SUBJECT: U.S. NUCLEAR REGULATORY COMMISSION REVIEW OF HOMESTAKE MINING COMPANY OF CALIFORNIA'S REQUEST TO START POST-CLOSURE MONITORING FOR THE WESTERN PORTION OF THE NORTH-OFFSITE AREA DATED 15 AUGUST 2017, DOCKET NO. 040-08903, LICENSE NO. SUA-1471

U.S. NUCLEAR REGULATORY COMMISSION STAFF
TECHNICAL EVALUATION REPORT

SUBJECT: Request to Start Post-Closure Monitoring for the Western Portion
of the North-Offsite Area

Figure 2. Alluvial Aquifer Compliance Monitoring Well Locations (adapted from HMC's Groundwater Monitoring Plan License Amendment Request)

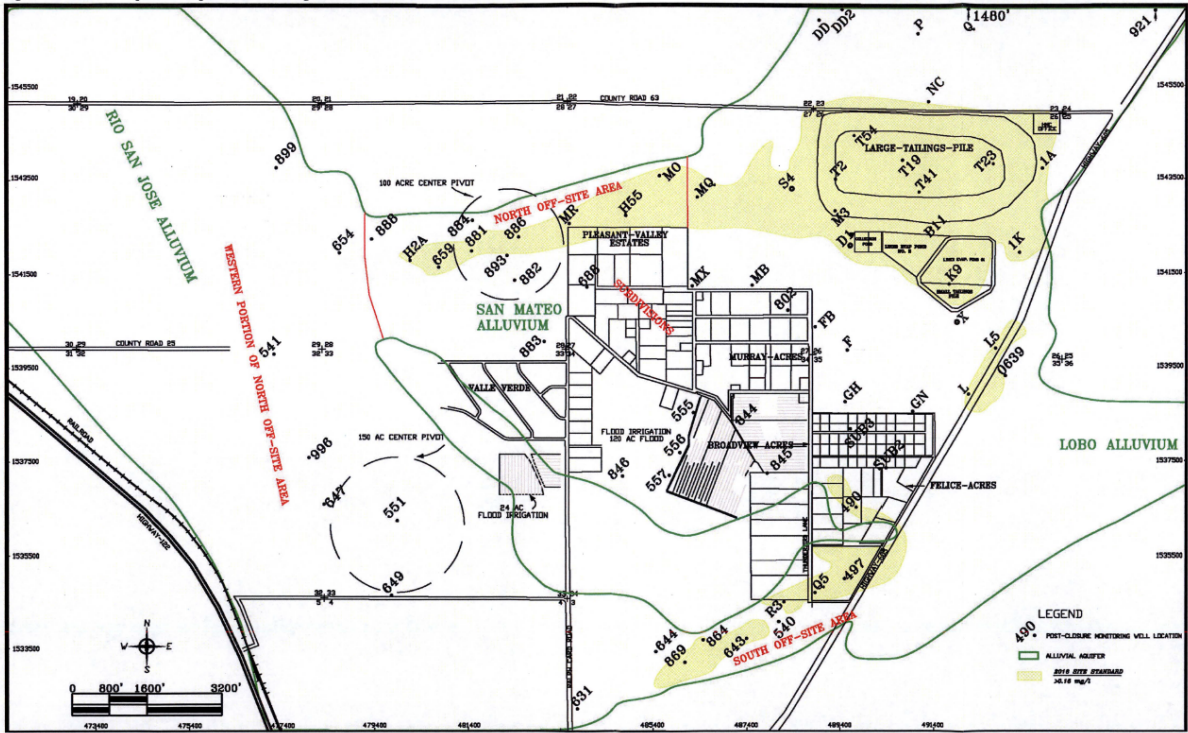
As shown in Figure 2 below, which was adapted from HMC's Groundwater Monitoring Plan LAR dated November 20, 2017, the seven wells proposed by HMC for post-closure monitoring are the compliance monitoring wells for the western portion of the North-Offsite area shown in the Groundwater Monitoring Plan LAR. The Groundwater Monitoring Plan LAR was approved by the NRC by license amendment dated November 12, 2019.⁹ Although these wells currently meet the groundwater protection standards for uranium (i.e., <0.16 mg/L) and other constituents of concern, the NRC, in coordination with the Agencies, are unable to determine that these concentrations are representative of steady-state conditions and that the corrective actions have been fully effective. The injection wells and lines, shown in green in Figure 3 below, could result in dilution downgradient as the collection wells may not capture all of the injectate, which consists of reverse osmosis and zeolite treated-water and fresh water from the San Andres Glorieta aquifer. Therefore, the observed concentrations in this monitoring area might not be representative of the long-term state of the alluvial groundwater in the western portion of the North-Offsite area. Additionally, a Groundwater Corrective Action Plan (GCAP) LAR for the Grants site was submitted to the NRC for review and approval on December 18, 2019.¹⁰ Initial review of the GCAP shows corrective actions at the Grants site extending into 2035 for final completion. Lastly, EPA, under its authority of the Comprehensive Environmental Response, Compensation, and Liability Act (CERCLA), is currently reassessing background and the groundwater protection standards approved by the NRC as part of the ongoing CERCLA remedial investigation and feasibility study equivalency analysis process being performed by the Licensee. If the groundwater remediation goals to be established by EPA in a future record of decision are below the currently approved NRC standards, then additional groundwater remediation may be required to achieve such CERCLA remediation goals in the western portion of the North-Offsite area. Accordingly, the NRC, in coordination with the Agencies, have determined that it is premature to start post-closure monitoring for the western portion of the North-Offsite area.
